IX Padmaja Naidu Himalayan Zoological Park, Darjeeling
273
Proposed construction of an aviary

XI Biological Park, Itanagar

(iv) Construction of Boundary wall

BOUNDARY WALL AT BIOLOGICAL PARK - ITANAGAR

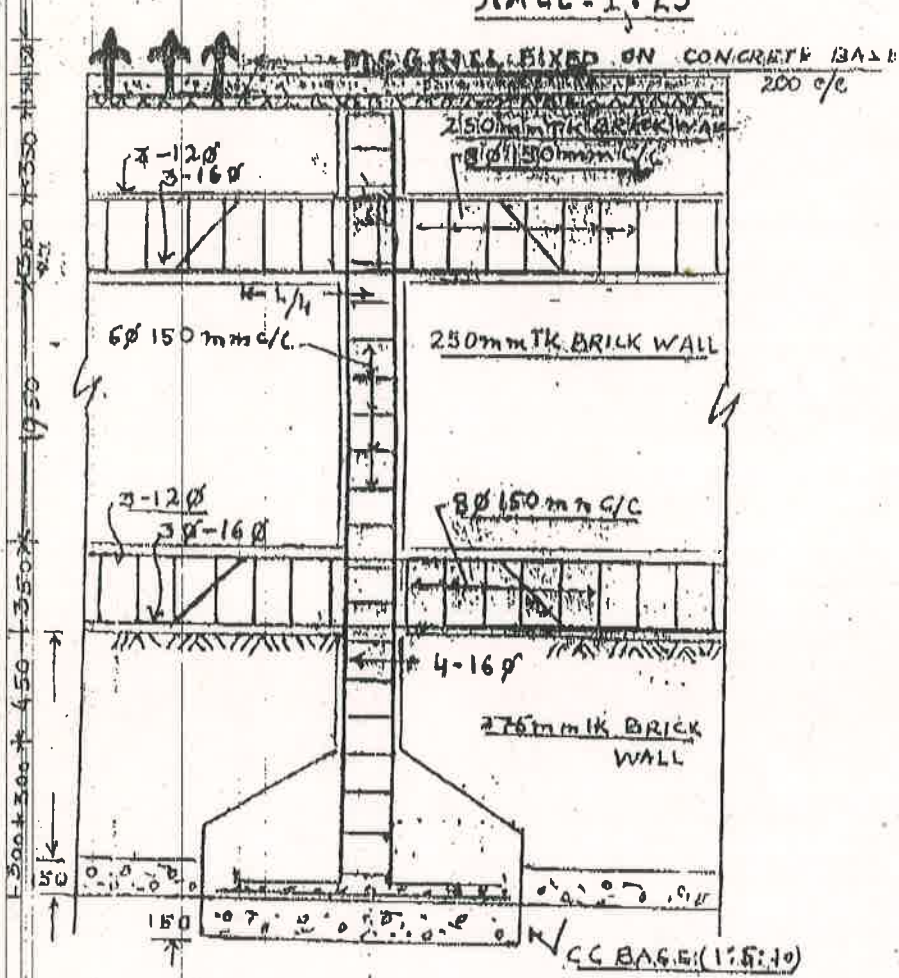
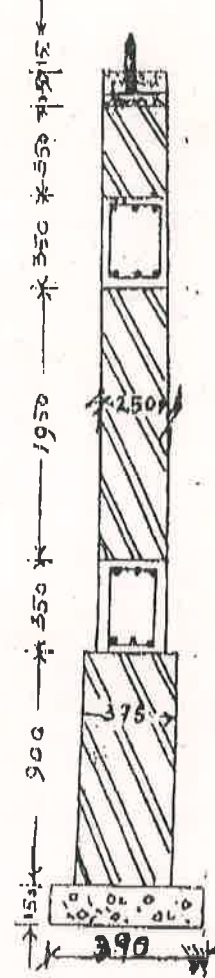
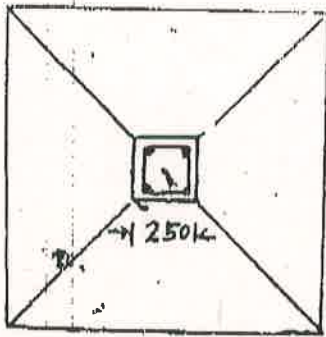
The design was approved subject to the following modification shall be carried and revised design should be submitted:-

- (a) Reinforced beam through out the boundary wall is needed.

- (b) The boundary wall should be created towards the Zoo as per the design to the residential colonies. The height of the boundary wall should be restricted to 7 feet from the ground level with 1.5 feet pointed rope. The remaining boundary of the Zoo should be provided with the chainlink fence of 2 meter high with 2 strand barbed wire. This will reduce the length of the periphery wall upto 4 km. (2 km. wall @ Rs.30.00 lakhs per km.+ 2 km. fencing @ Rs. 19.00 lakhs per km. approximately.
